NOTICE OF ADDENDUM ADDENDUM NO. 1 City of Madison, Engineering Department

February 8, 2019

CONTRACT NO. 8238 METRO TRANSIT PHASE 1 – SERVICE LANE ADDITION

DRAWN BY: MJE CHECKED BY: DXC SHEET CONTENTS ROOF LOADING PLAN

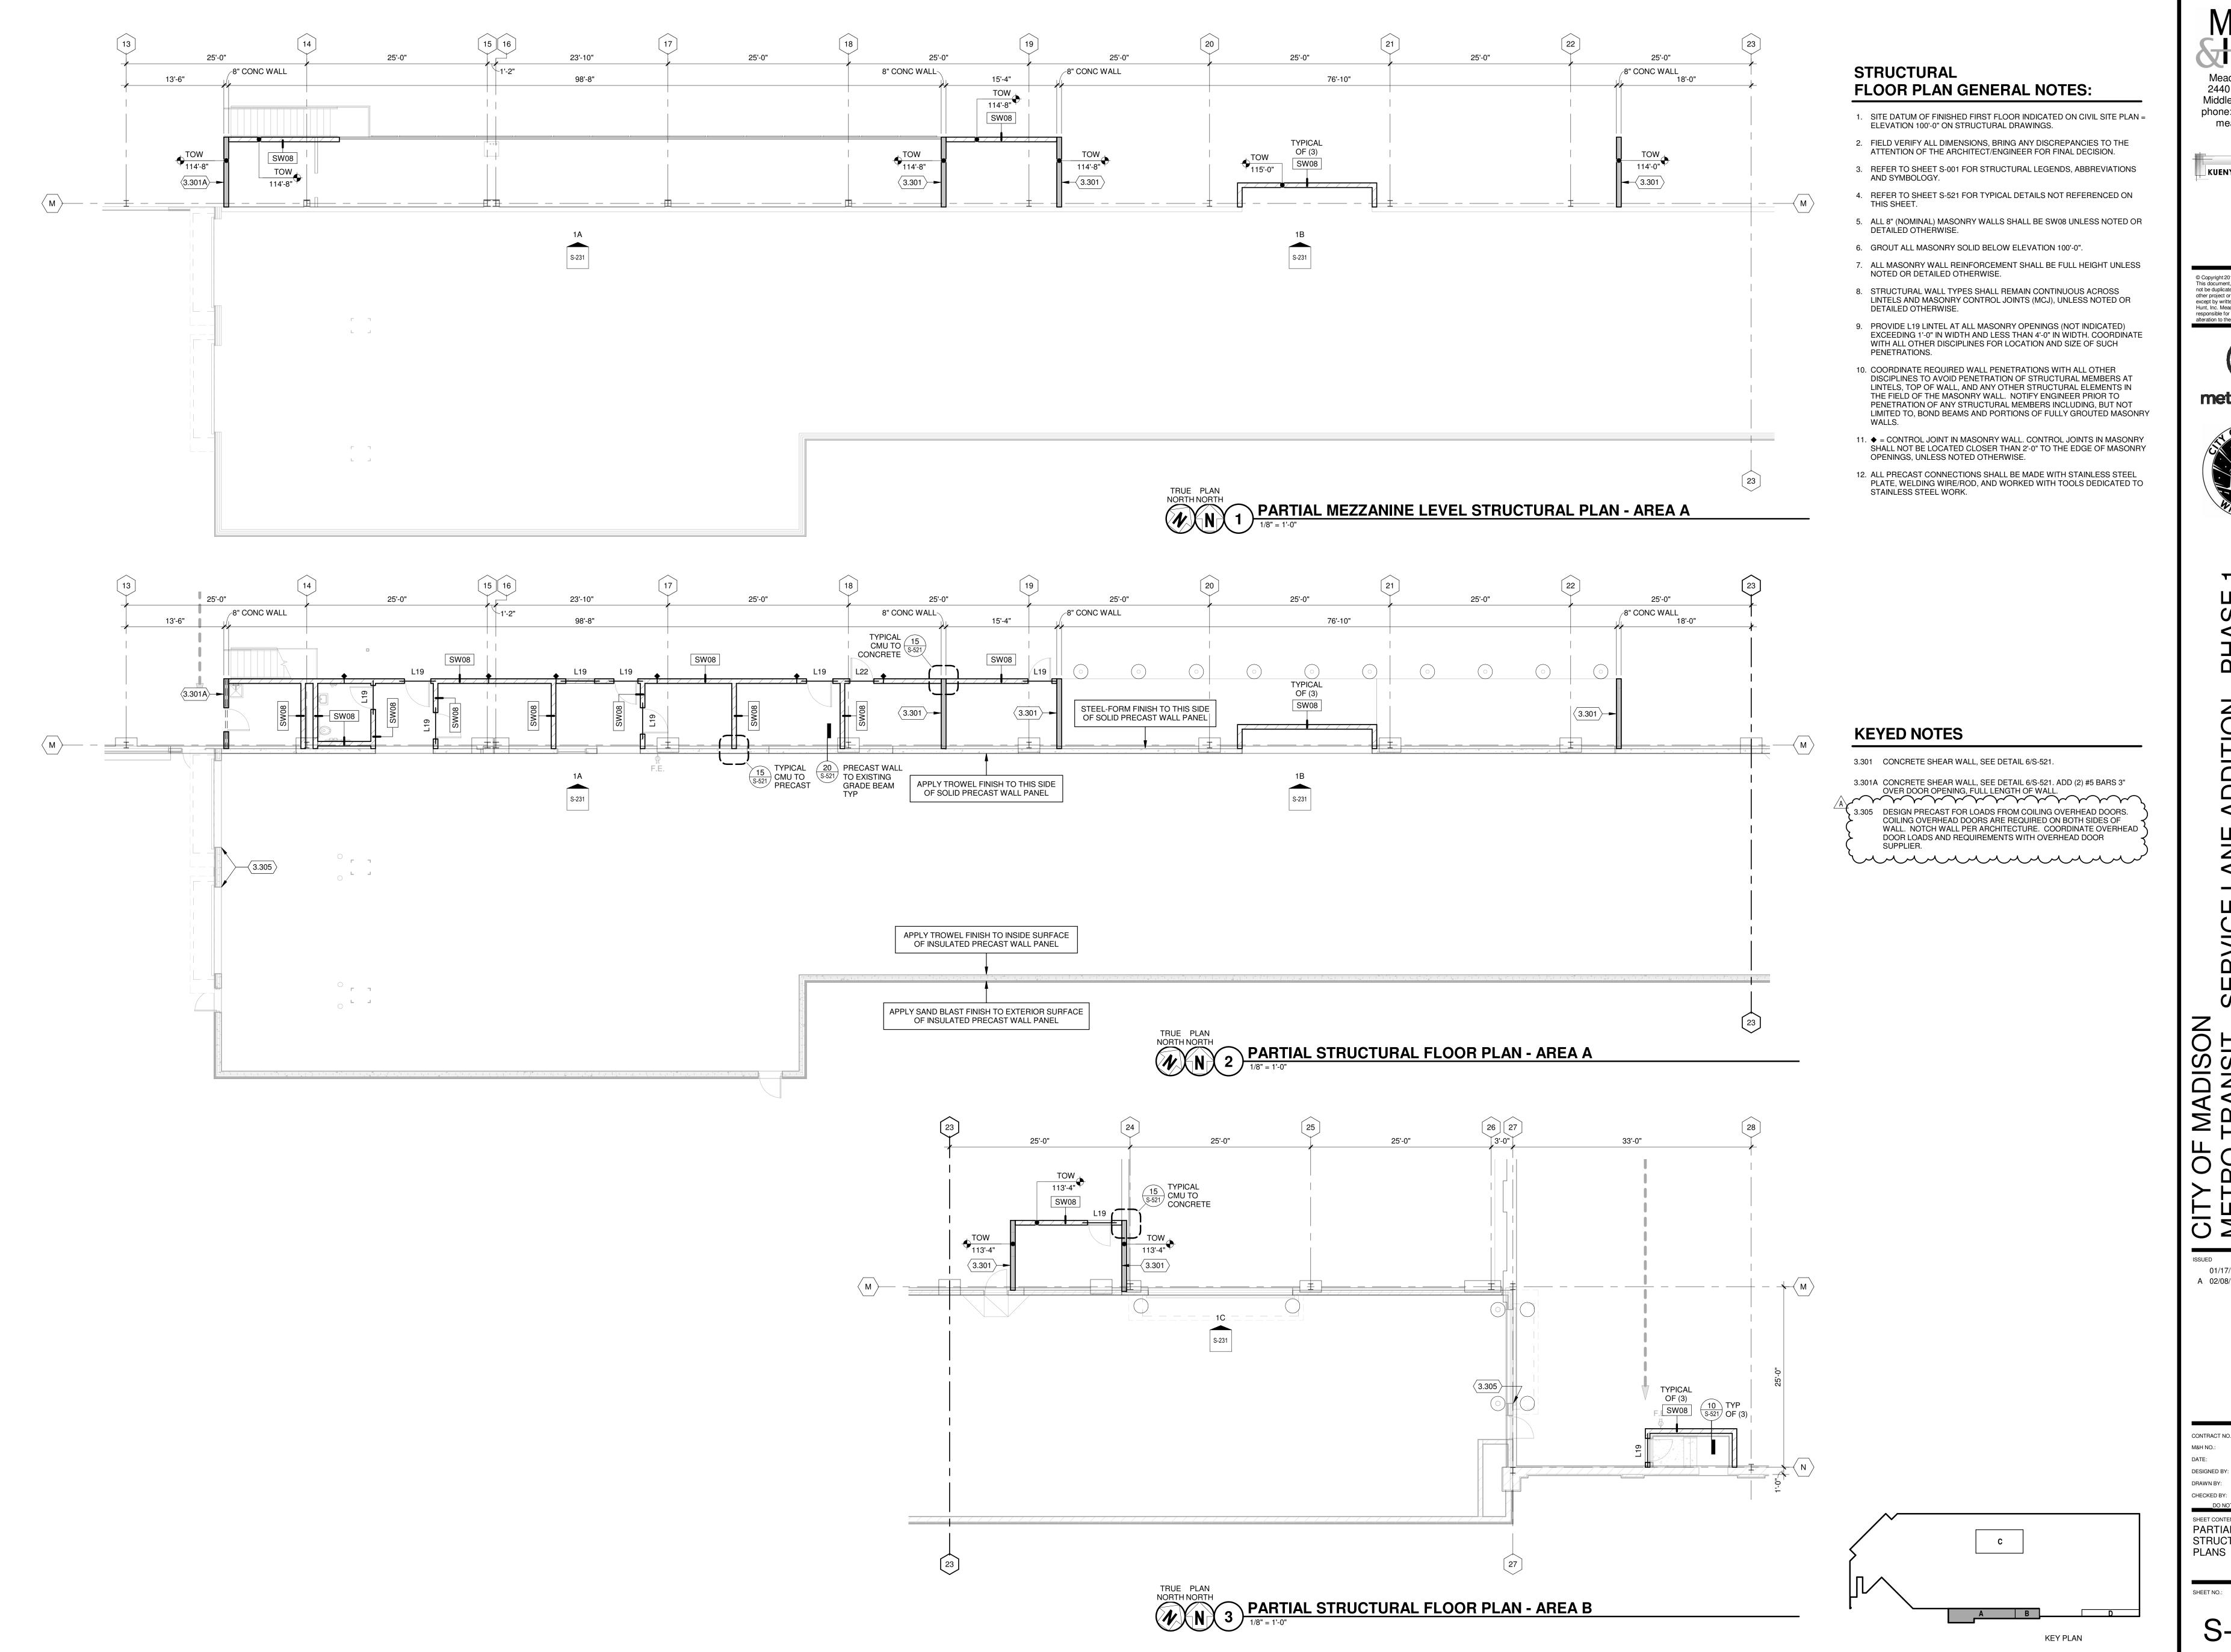
- i. Drawing S-010, (attached), revise roof loading requirements as shown.
- ii. Drawing S-131, (attached), revise note 3.305 regarding the overhead door requirements of the precast.

E-100

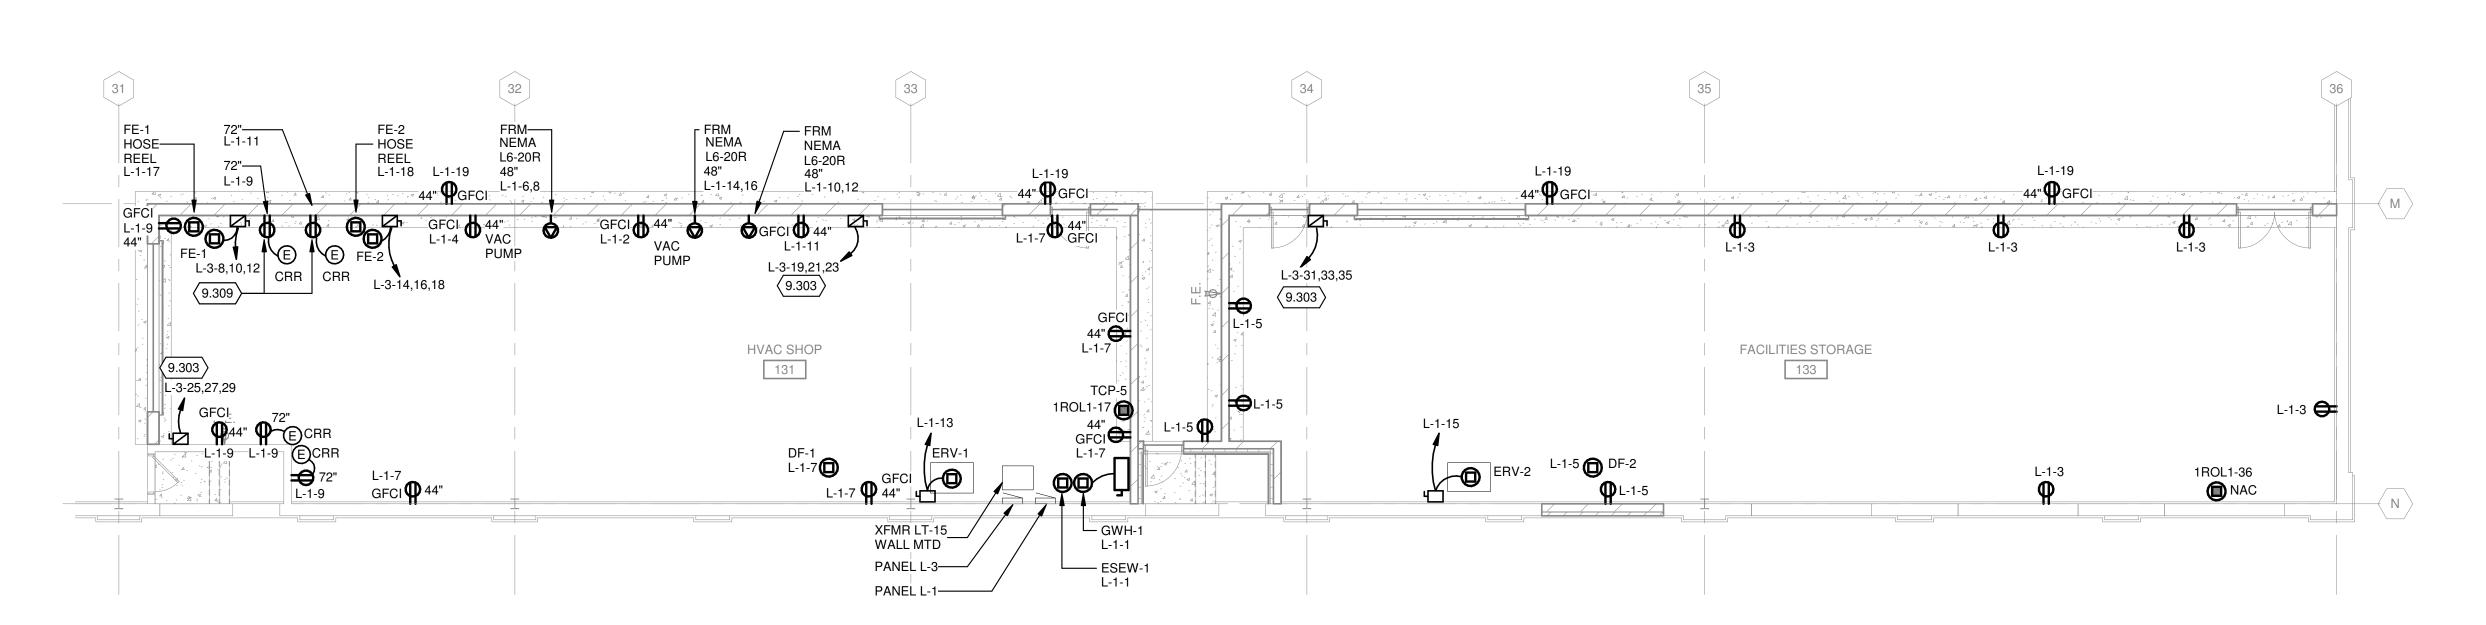
- i. Drawing E-100(Attached)
 - Revised location of future E-Bus Dispenser rough-in locations as shown.
 - Revised keyed note 9.304 to clarify rough-in is for future E-Bus Dispenser(s).
- ii. Drawing E-102 (Attached)
 - Revised location of future E-Bus Dispenser rough-in location from column line E/20 to near column line F/19.
 - Revised keyed note 9.304 to clarify conduit rough-in for future E-Bus Dispenser rough-in location.
